# 23-007-TRC

## Site Plan Review Staff Report

**Applicant | Park Street Okeechobee, LLC**

*Prepared for The City of Okeechobee*

1000 STATE ROAD 70 E, OKCHOBEE, FLORIDA 34972  
JOHN J. HERBERT IV, P.E.  
LIC # 84698  
10/22/2023  
SITE PLAN  
PROJECT NO. 22640  
C4.0

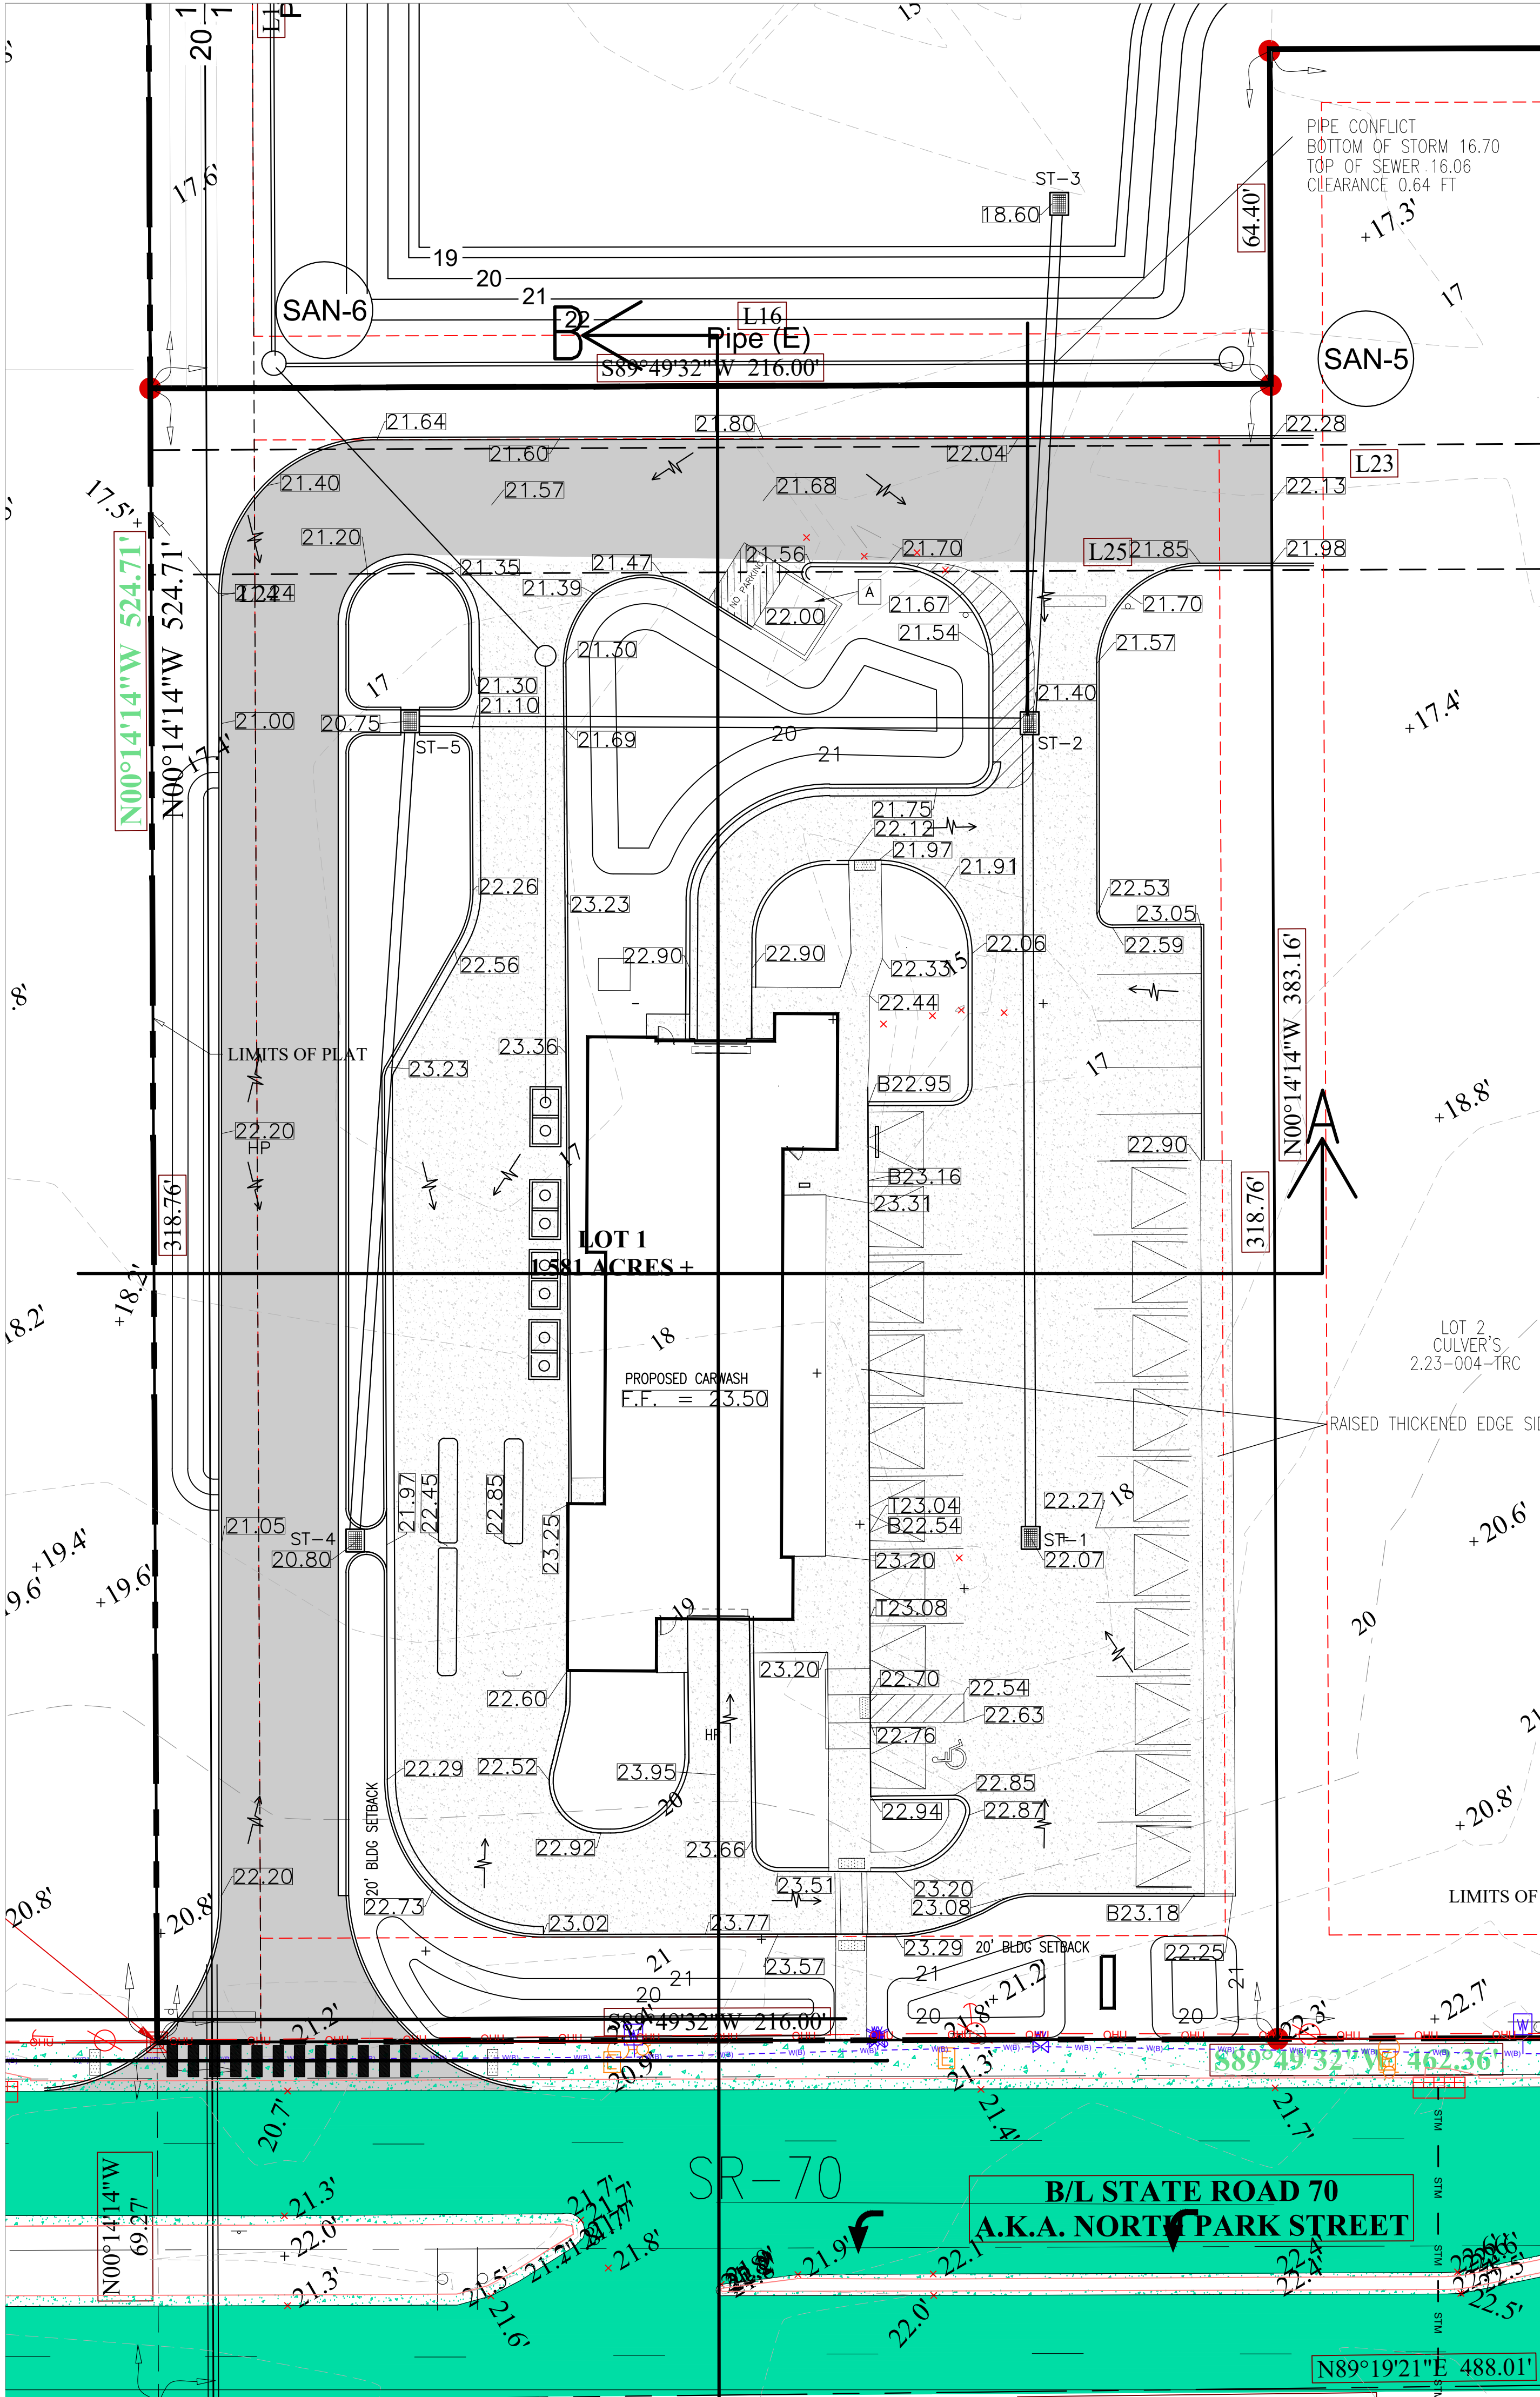
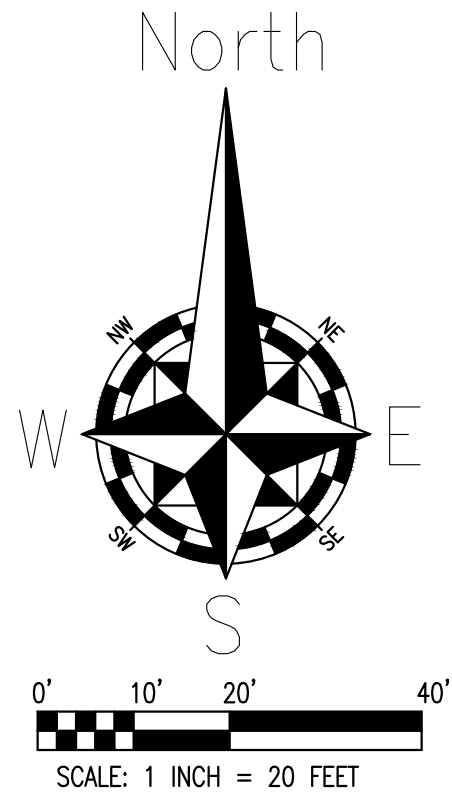
The applicant is requesting that the TRC approve a parking reduction as part of the site plan approval. The LDC requires 31 parking spaces for the 4,596. Staff analysis of the submitted application and plans is provided below. Areas of deficiency or concern are highlighted in yellow.

The site plan depicts a dumpster within a 10'x12' enclosure with direct access via the cross access easement/roadway on the north side of the site. Sufficiency of the dumpster enclosure and location will be addressed by Okeechobee Public Works dept.

<b>Parking Reduction Requests §90-483</b>	Applicants that submit site plans for review by the technical review committee may request approval of parking reduction concurrently with site plan approval	Applicant has provided examples of other car washes throughout the state, identifying number of spaces at each site. No other information (i.e. facility dimensions or operational

1. Plans must be consistent with final plat approval and all conditions of that approval.
2. Provide at least 25 parking spaces, which is the minimum that may be permitted after granting of parking reduction request.
3. Provide a landscape island consistent with 90-533(6).
4. Provide an additional bush within the eastern landscape perimeter buffer.
5. Revise landscape plan to depict all proposed plantings in appropriate locations. (current landscape plan depicts a tree in parking space)
6. Approval of this site plan is contingent on approval of special exception request 23-002-SE.
7. Approval of this site plan is contingent upon obtaining all necessary approvals related to the proposed SR-70 access point.
8. No building permit may be issued until all conditions of approval of 23-003-TRC have been met.
